Subject: AP1000 Response to Request for Additional Information (SRP 7)

RAI-SRP7.3-ICE-02 R2

AP1000 TECHNICAL REPORT REVIEW

RAI Response Number: RAI-SRP7.3-ICE-02

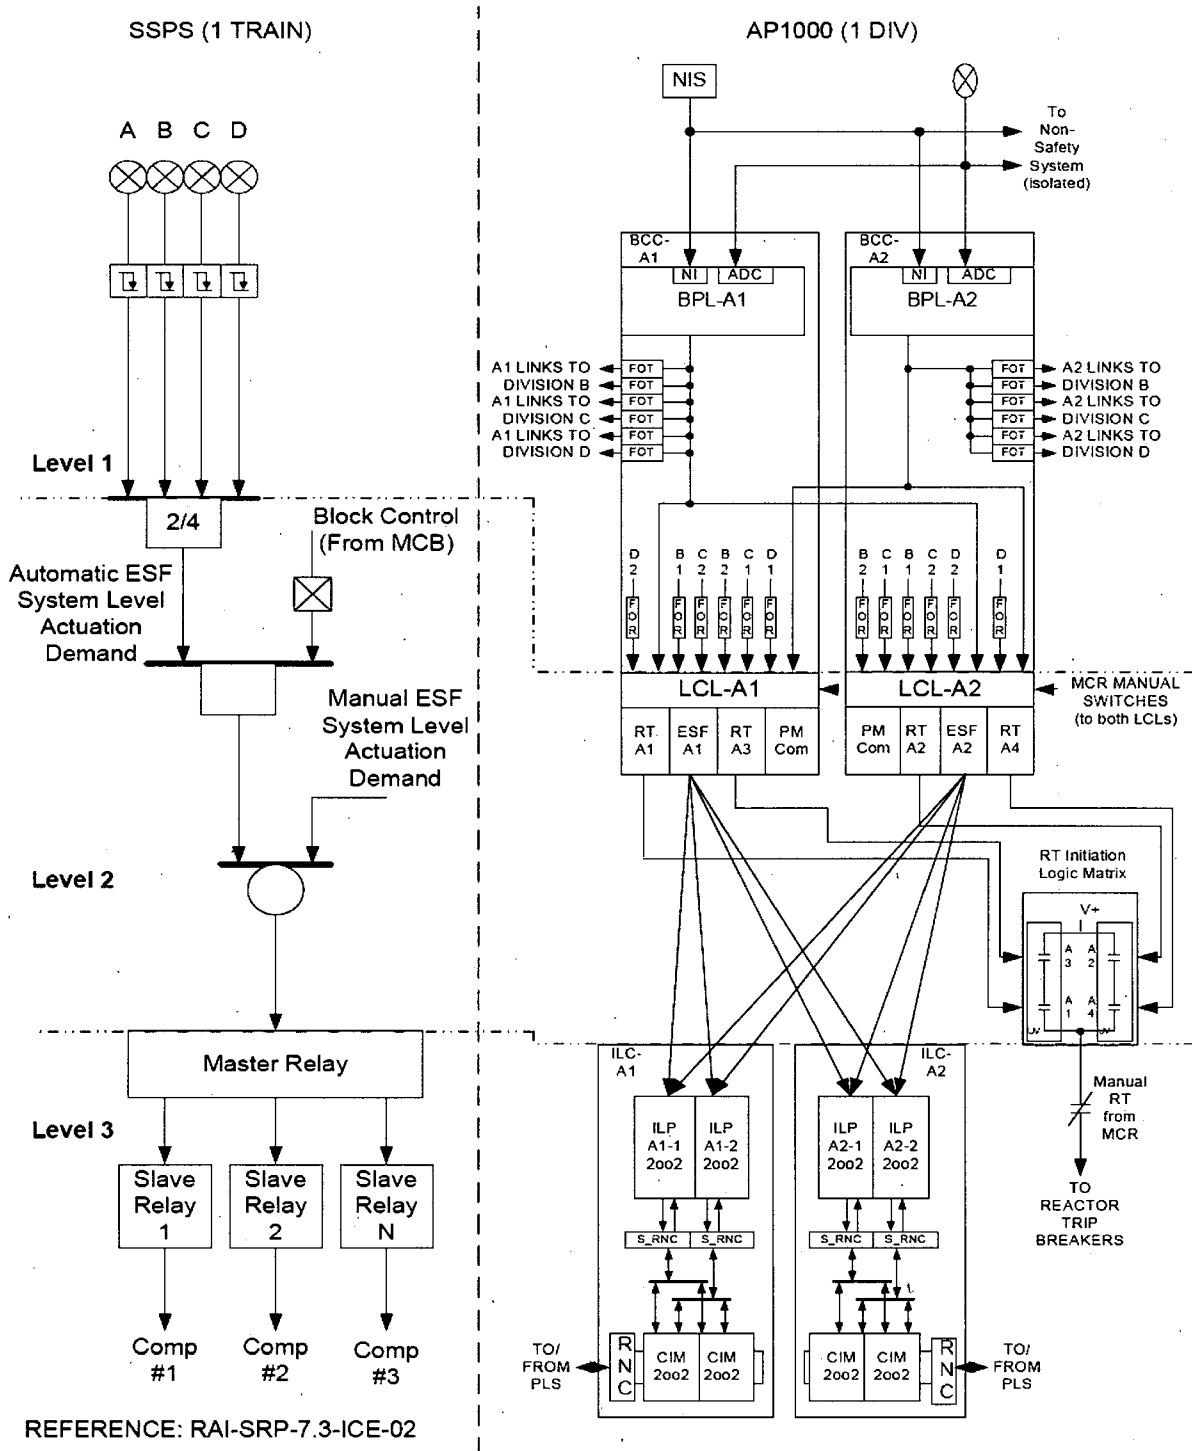
NRC requested additional information to depict the correlation between the conventional solid state protection system (SSPS) and the protection and safety monitoring system (PMS).

Added attached sketch depicting the ESF actuation path and the correlation between a conventional SSPS system and the PMS. The attached sketch depicts the correlation, showing the Level 1, 2, and 3 functionality.
